Ragadi Textiles Ltd

Kainjanul, Mirazapur, Dhaka
(24.0788N, 90.3569 E)

30 October, 2013

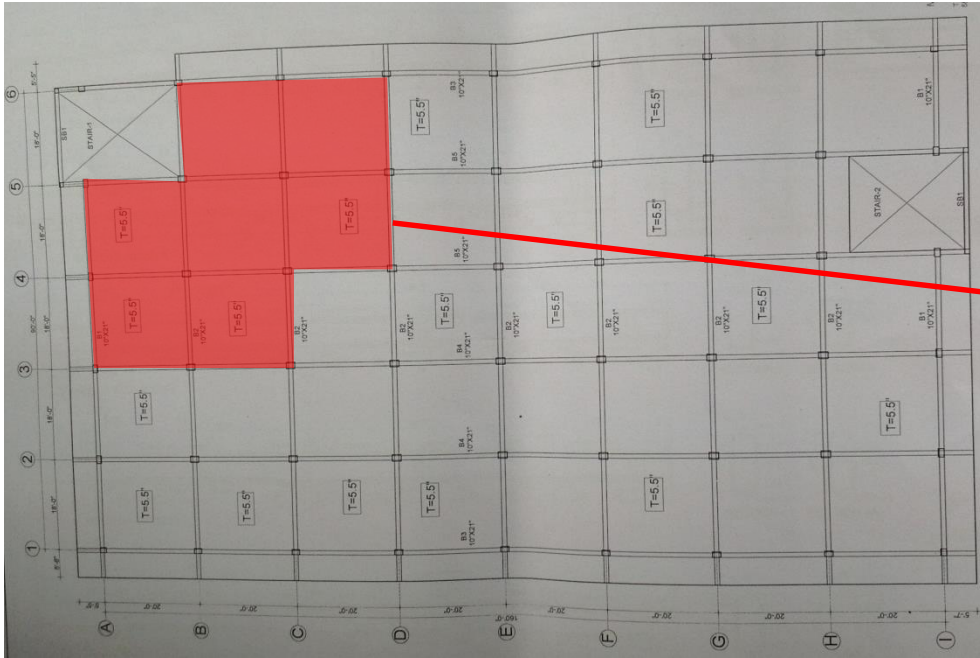
Check on columns required

Not shown on
either
Engineering OR
Permit drawings

Not shown on
permit drawings,
but shown on
engineering
drawings

4 storey + roof permit has
been obtained. 5 stories plus
additional roof structure has
been constructed so far –
engineering drawings show 6
storey building, but no roof
structure.

Check on additional floor and roof additions required

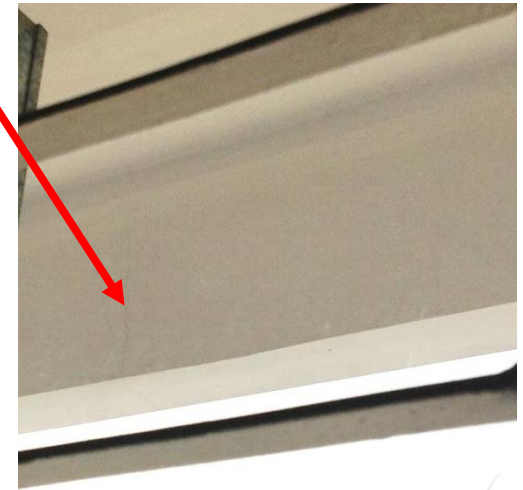
Ground floor column steel belting exposed to weather

Steel belting placed through exterior wall and welded during installation

Exterior steel belting exposed to weather

Protect exterior steel belting

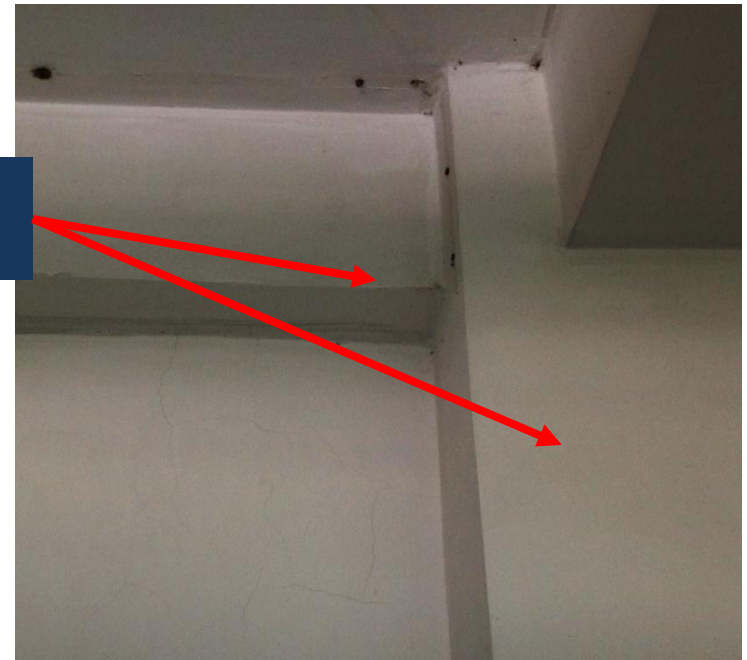
Non-structural hairline cracks in parapets, likely caused by shrinkage of concrete

Non-structural hairline cracks in brick in-fill, likely caused by beam movement

Non-structural hairline cracking

**Non-structural hairline cracks
in brick in-fill wall and beam**

**Non-structural hairline cracks
in stair wall brick in-fill, likely
caused by deflection of
cantilever landing**
